**Re: Notice of Intent to Hydrostatically Test and Discharge
Transwestern Pipeline Company, LLC
Loop A 36-inch Pipeline Project
NW ¼ of Section 21, Township 28 North, Range 11 West, NMPM,
San Juan County, New Mexico**

The following request for additional information is based upon TRC's January 16, 2008 submittal:

**Hydrostatic Test Discharge Permit Application
Transwestern Pipeline Company, LLC
Loop A Milepost 6.82/Station 360+00**

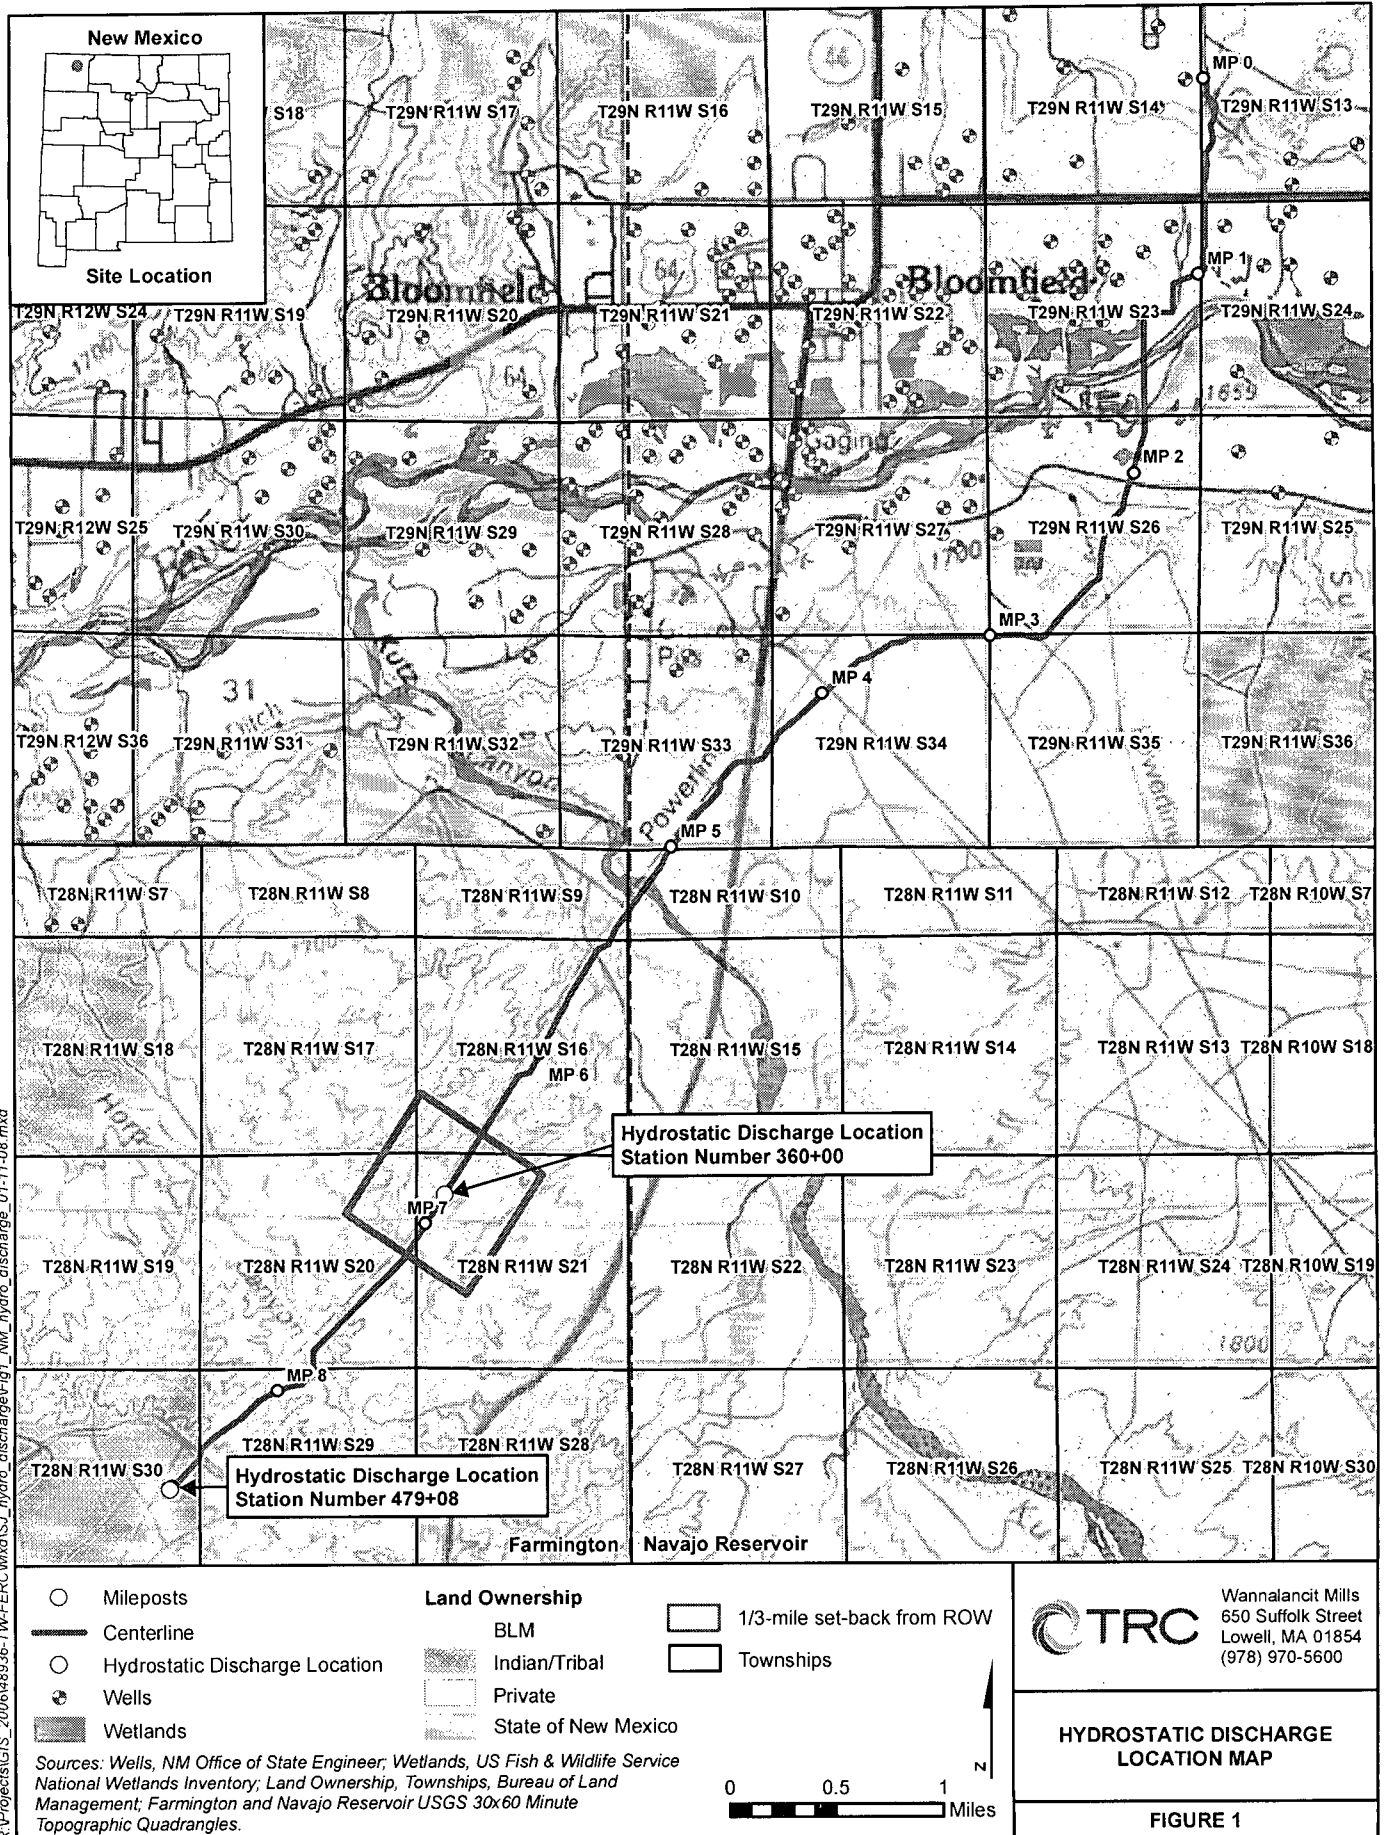
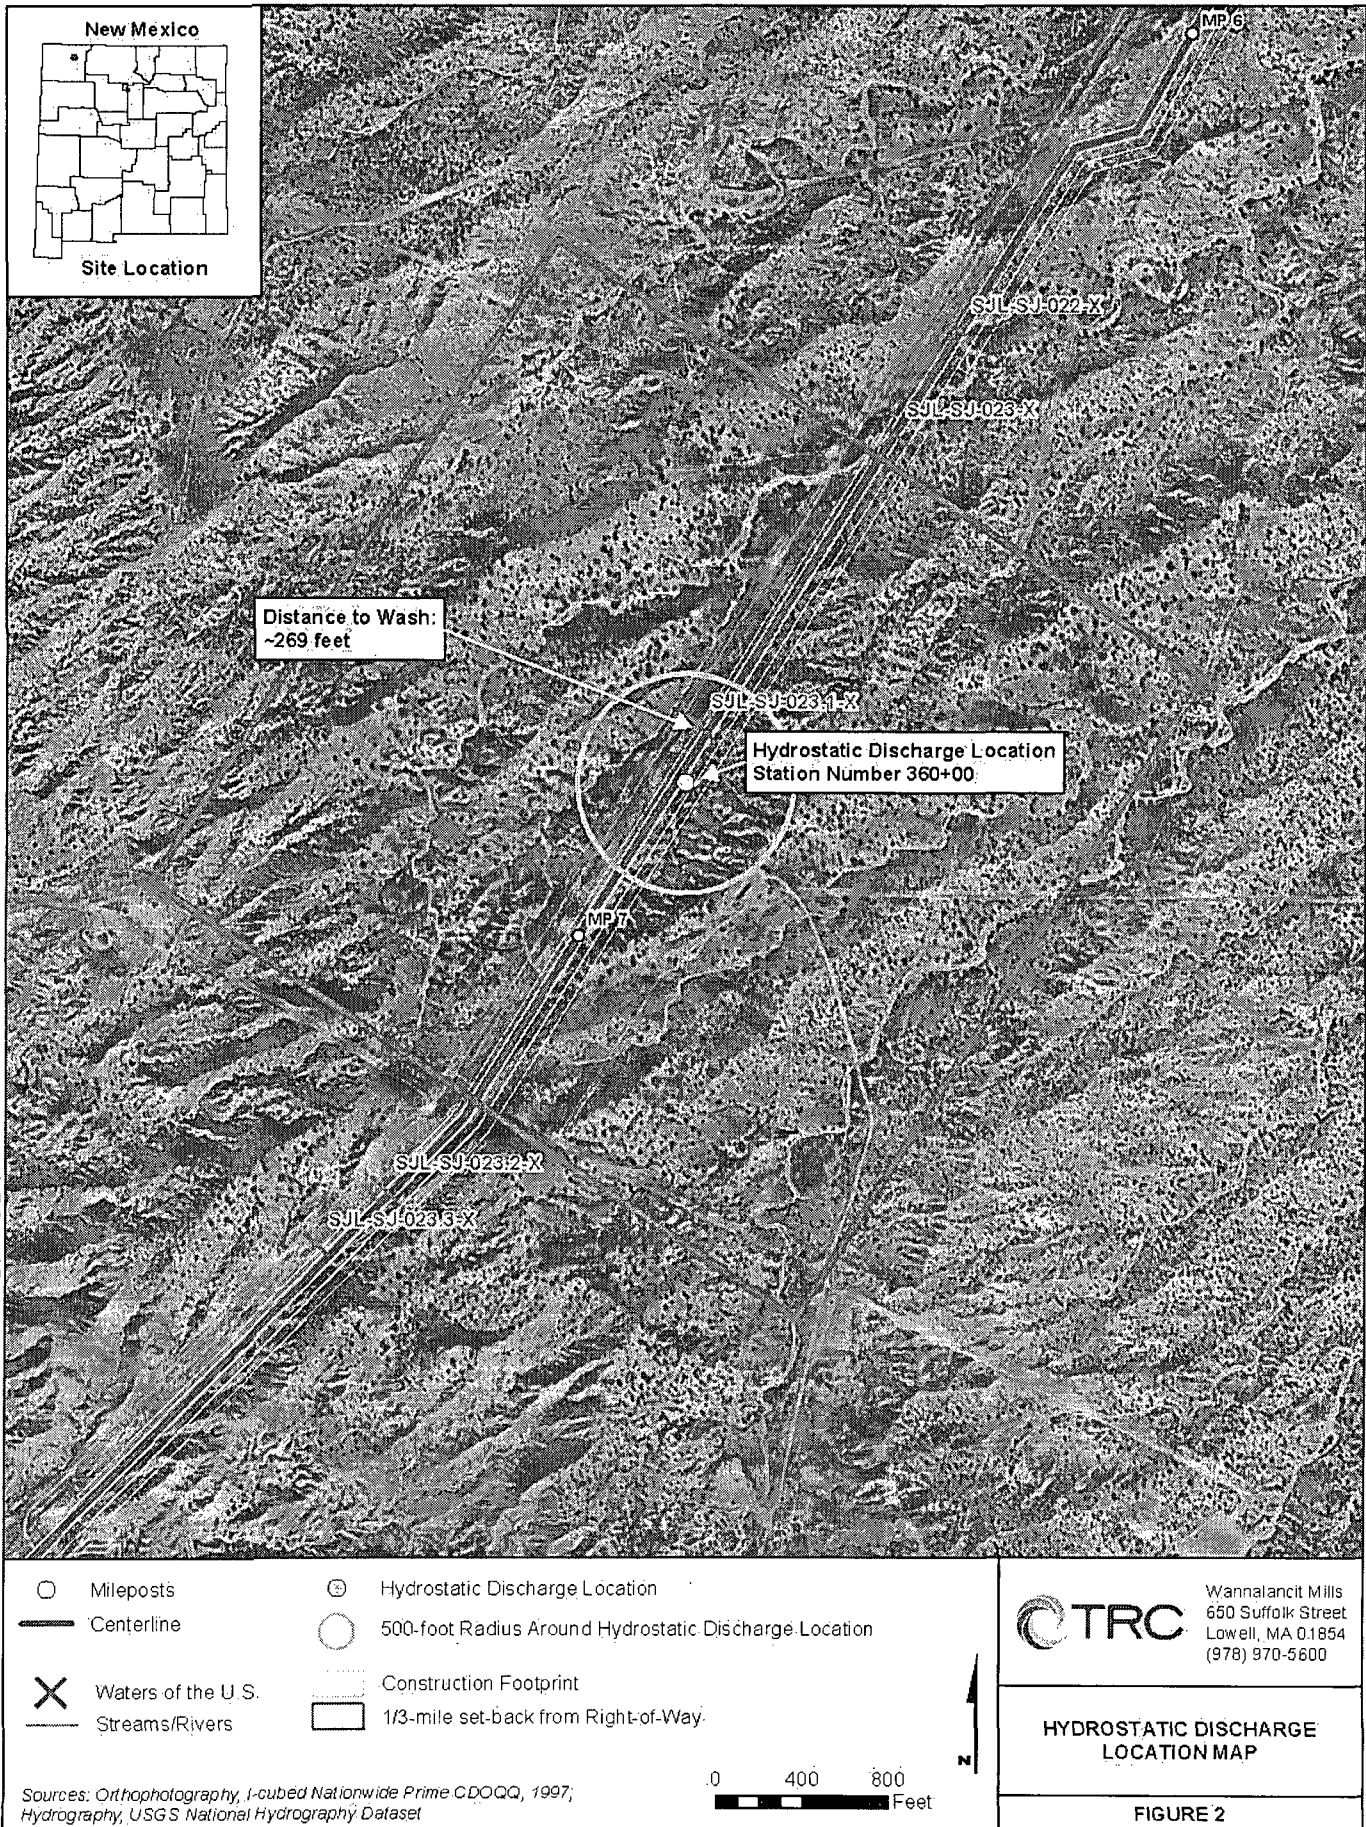
Page 1, Section D: Please provide site specific maps that illustrate and establish the easement right-of-way of the proposed discharge location area. Please reference the location of the supporting maps in this section.

Please provide site specific maps illustrating the proposed collection and potential discharge location and area of the hydrostatic test wastewater. The site specific maps should demonstrate the topography of the proposed collection and potential discharge location. If the proposed method of disposal involves the discharge of hydrostatic test wastewater along the pipeline right-of-way, a map of the pipeline right-of-way is required to demonstrate compliance to the siting criteria.

Figures: Please provide site specific maps illustrating the proposed collection and potential discharge location of the hydrostatic test wastewater. If the proposed method of disposal involves the discharge of hydrostatic test wastewater along the pipeline right-of-way, a map of the pipeline right-of-way is required to demonstrate compliance to the siting criteria. If the pipeline right-of-way extends beyond the proposed collection and temporary storage initial legal description, the legal description must be modified to include the pipeline right-of-way of the potential discharge.

Typical Surface De-watering Structure

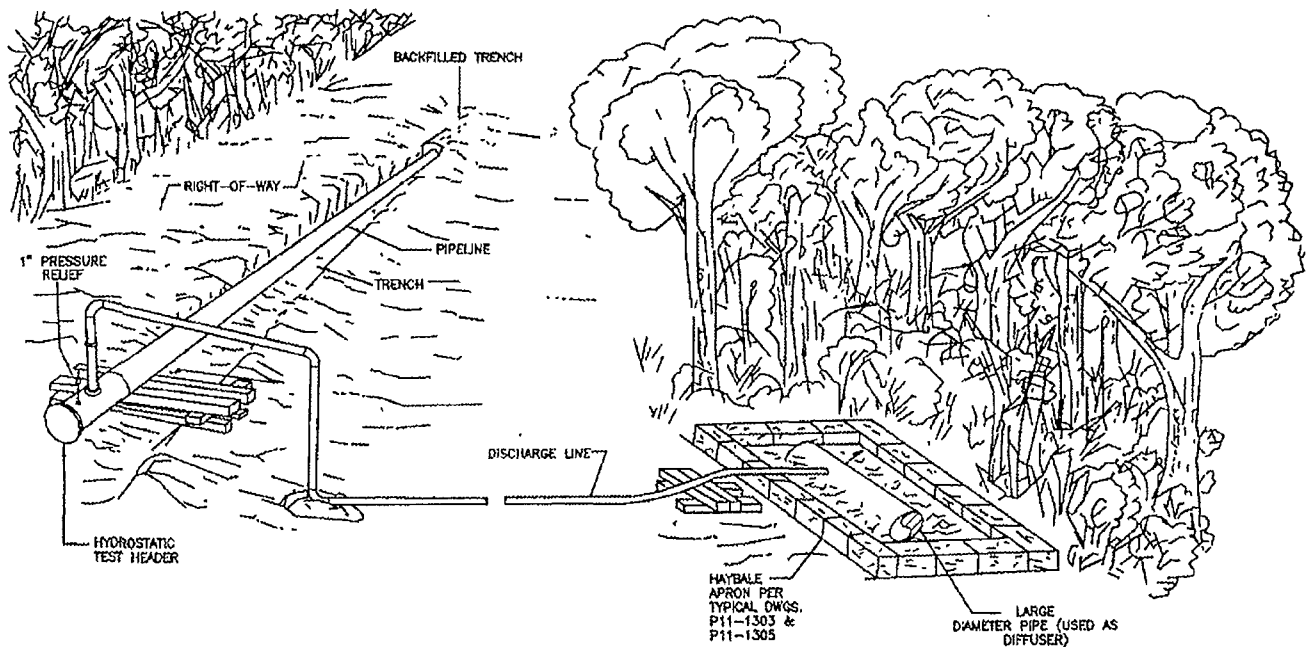
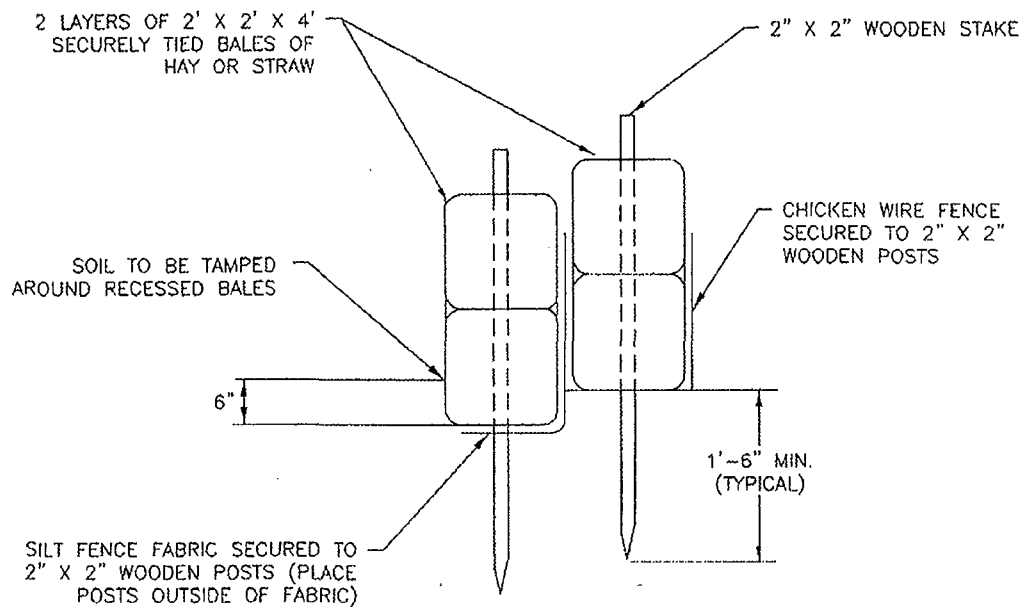
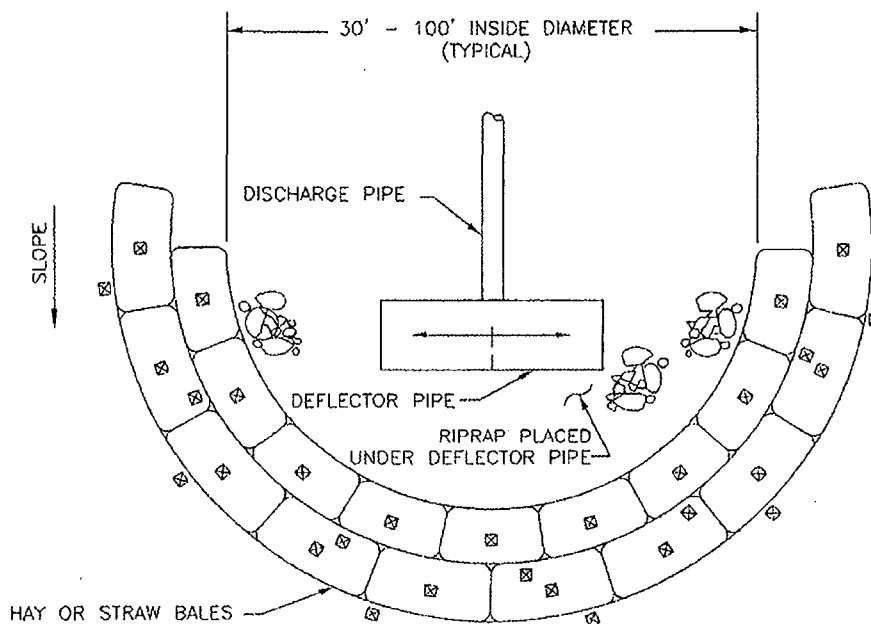
Page 2, Section F: The response provided in this section suggests that the discharge flow rate will vary between 600 and 1,200 gallon per minute. OCD has some reservations regarding containment of the discharge within the easement right-of-way and erosional issues due to proposed high volume discharge rate. OCD is unable to assess the proposal because the NOI does not provide any information regarding the size and dimensions of the straw bale dewatering structure. Please justify the discharge flow rate and provide a letter from the BLM stating their assessment (approval or disapproval) of the proposed discharge method.

Page 3, Section H: Please provide site specific maps illustrating the proposed collection and potential discharge location of the hydrostatic test wastewater. Please describe the methods that will be implemented to contain the discharge within the easement right-of-way.
